## 1. MetroLink - Module 1

Witness Statement by Kenneth Goodwin on Behalf of Charlemont & Dartmouth Community Group in relation to Airborne Noise and Vibration

Figure 1: Extract from Appendix A13.1 – Appendix B

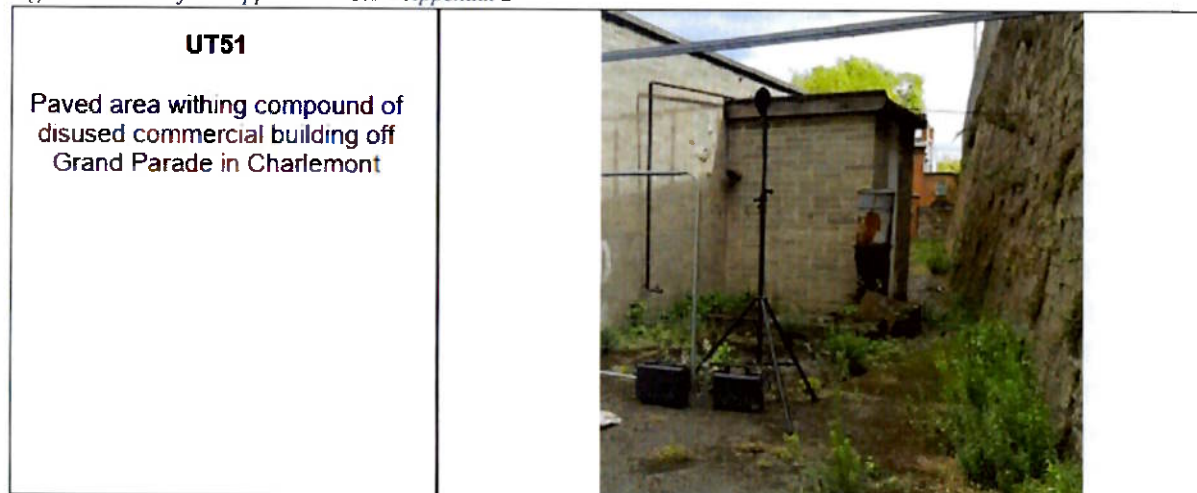
For unattended locations, values are 3dB lower than attended, however location UT51, located near the Luas Rail Embankment as presented in Appendix A.13.2, and presented in Figure 1 below, is not best practice for baseline monitoring due to the reflective walls located either side of the sound level meter, absence of a noise receptor in proximity, and sheltering aspect, however there is no mention in the EIAR for the inclusion or omission of this location from the assessment undertaken.

It is further understood that the short-term measurements undertaken along this area were post processed to a long-term average  $L_{DEN}$  utilising the NRA guidance methodology for road traffic. However, information on how this methodology is fit for purpose for an urban area, where road traffic is not in constant motion, and where road traffic is not the sole dominant noise source, is missing from this assessment methodology.

Figure 2: Extract from Drawing ML1-JAI-EIA-ROUT\_XX-DR-Y-05060.

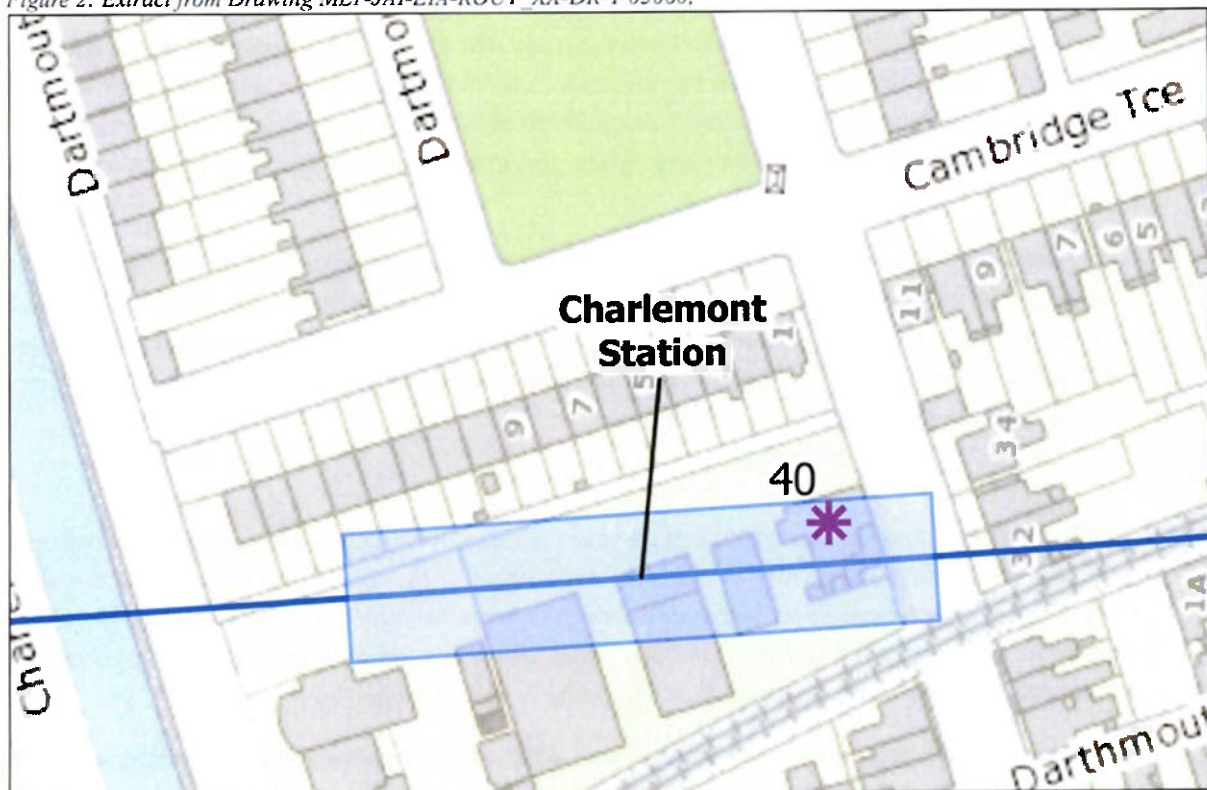
From Chapter 5, drawing ML1-JAI-EIA-ROUT\_XX-DR-Y-05060 as presented below in Figure 2, and Appendix A.5.8 Table 2-1, 19 and 19A Dartmouth Road are proposed to be demolished. However, in Chapter 5 in Table 13.38 there is no specification of a demolition phase related in Zone AZ4 and the effect of this demolition at the closest receptors.

Furthermore, it is confusing why buildings proposed to be demolished, presented in Section 8.4 of this report, are being included in pre-construction surveys for blasting vibration. Moreover, as TII have stated at different responses (i.e. Items 15 and 42 from Response 40 and Items 12 and 54 from Response 41) that drill and blasting will not happen at this location and mechanical excavation is going to be used.
